N472NAS3

# TECHNICAL BULLETIN

Service Action: Windshield Molding Tapping Noise

MODEL:	MODEL YEAR:	VIN:
Defender (LE)	2020	000584-008252

E266562

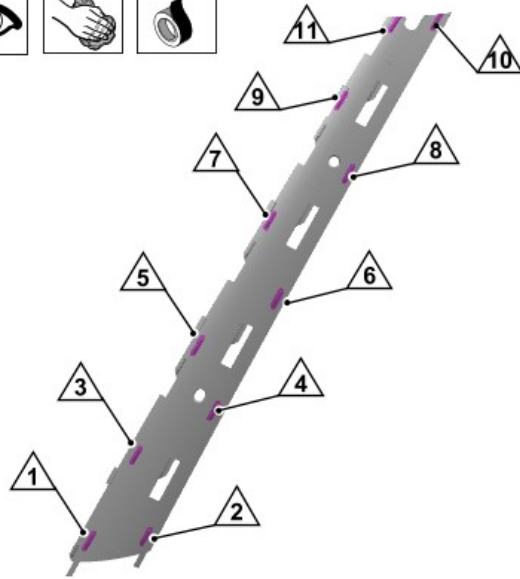
Locate the 11 windshield molding retaining ribs as shown highlighted.

- Clean the area around each windshield molding retaining rib.
- Apply felt tape to cover each of the 11 windshield molding retaining ribs as shown.
